UNION TOWNSHIP

# MODIFICATION TO OVERLAY DISTRICT PLAN

Owner / Applicant: Rupp Family Enterprises, LLC  
4385 Winding Creek Boulevard

## **STAFF REPORT: Case # 3-19-O**

## LANDSCAPE PLAN

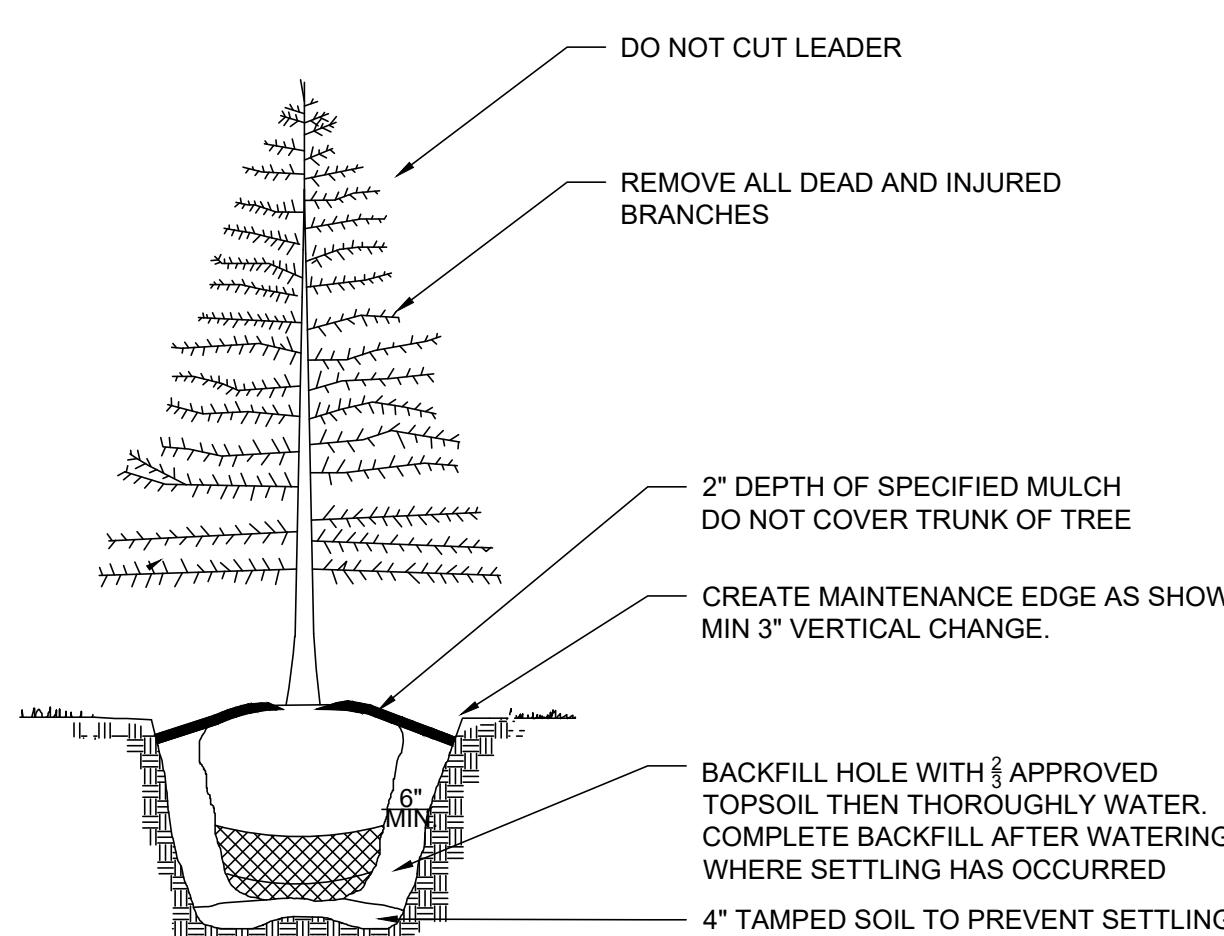
*According to a letter (dated 10/7/25) and signed by both the subject property owner and the adjoining property owner to the southwest (Fraley): “The trees of substantial character in the area discussed between the two properties appear to be out of the limits of disturbance and could remain post-development. If after land disturbance and grading for the proposed development takes place, and existing trees to remain post-construction are apparent, there are any gaps in natural screening greater than 10' in width, the Owner / Developer proposes to provide proposed landscaping consistent with the intent of the Landscape Plan included in the submittal package to supplement the natural screening between the two properties...”*

***Additionally, the proposed final elevations must match the renderings. This is an item that could be addressed administratively by staff.***
- 3) The Applicant would be required to provide an updated, more detailed, enhanced landscaping plan—to accurately reflect: the plant types, sizes, and locations; provide acknowledgements on the plans to identify the existing mature trees and vegetation areas that are intended to be preserved, including the south-southwest rear portion of the property; and to enhance any areas that may be deficient in the front and / or rear of the property on the amended plans.  
*This is an item that could be addressed administratively by staff.*

**A2.1**

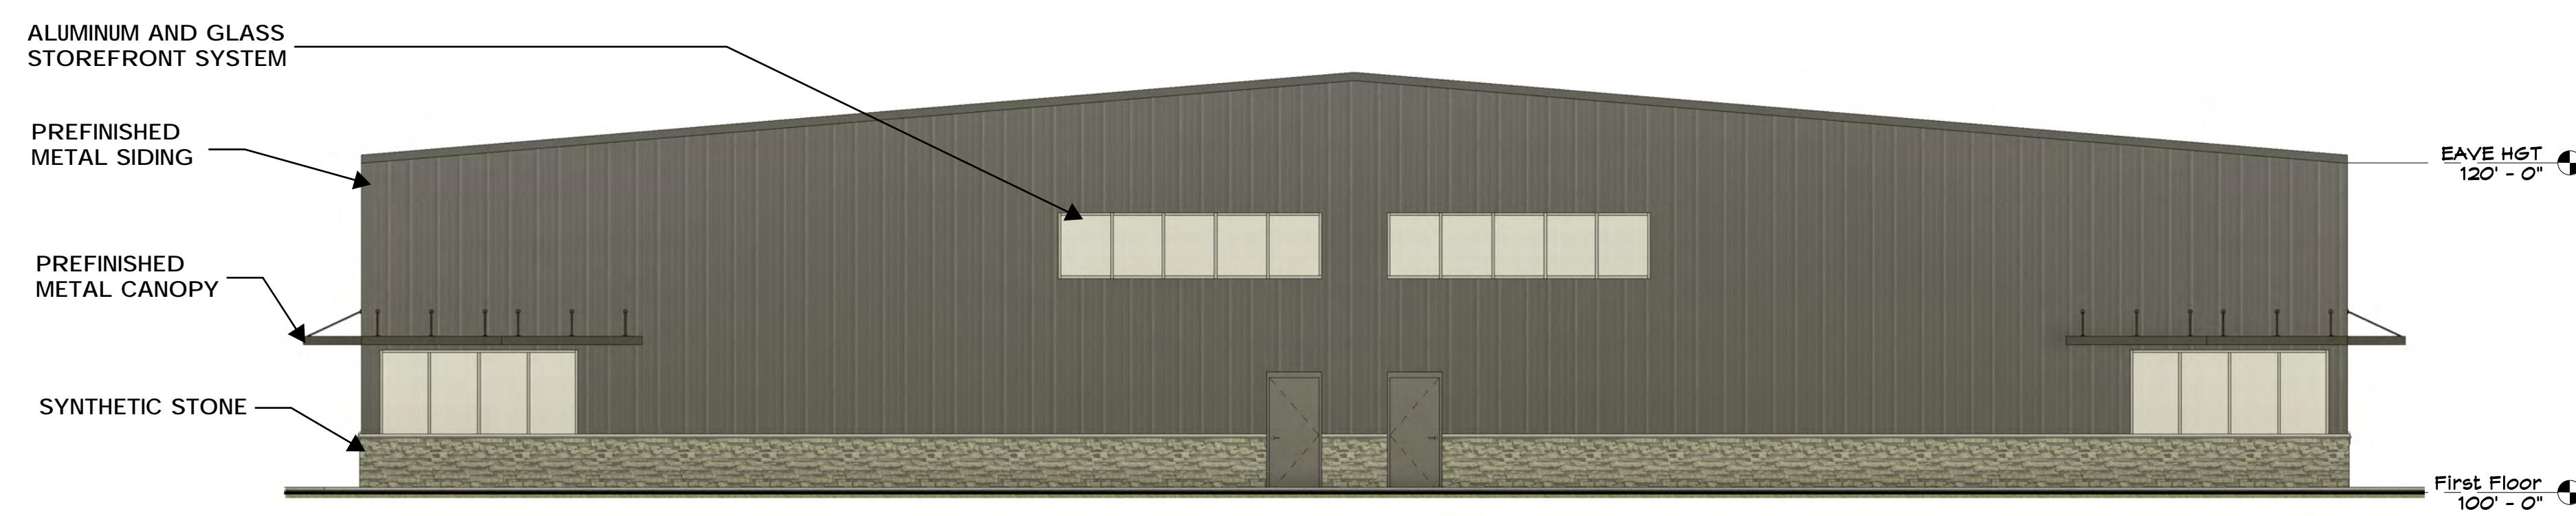
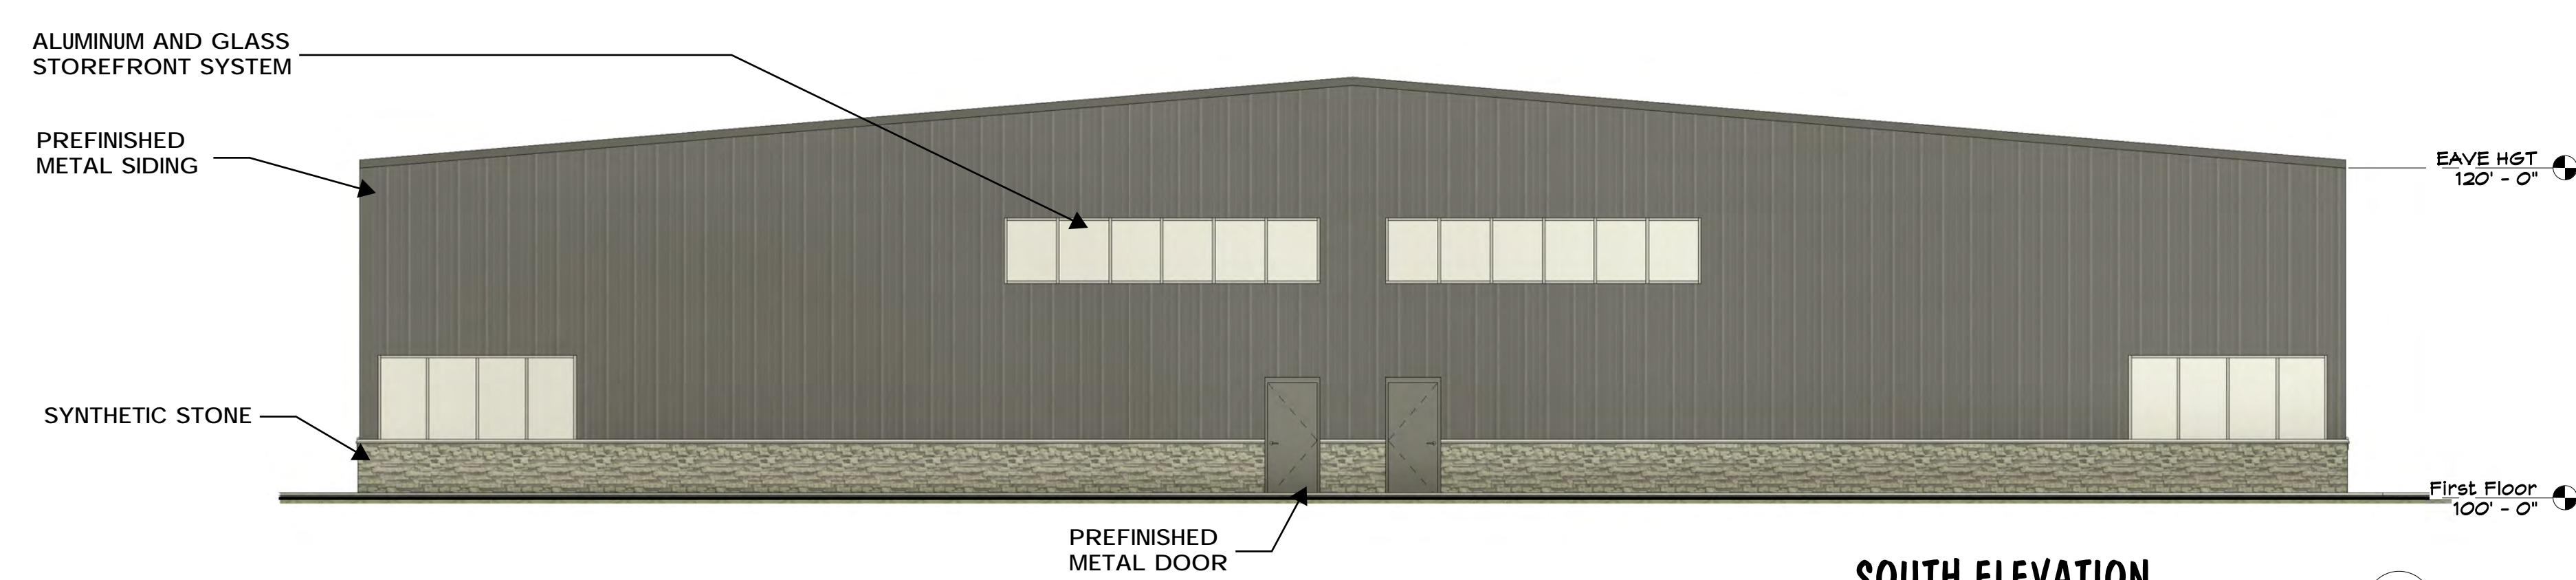
The height of the proposed structures appears to measure between 24-25 feet at the peak. Although architectural elevations have been submitted and there is some obvious use of traditional building materials, *staff recommends that additional traditional building materials and / or architectural design features be incorporated to enhance the visible corners of the proposed structures, to be more in alignment with the Comprehensive Plan.*

- 2) The Applicant may be required to modify the proposed building façade, so that additional traditional building materials and / or architectural design features are incorporated to enhance the visible corners of the proposed structures.
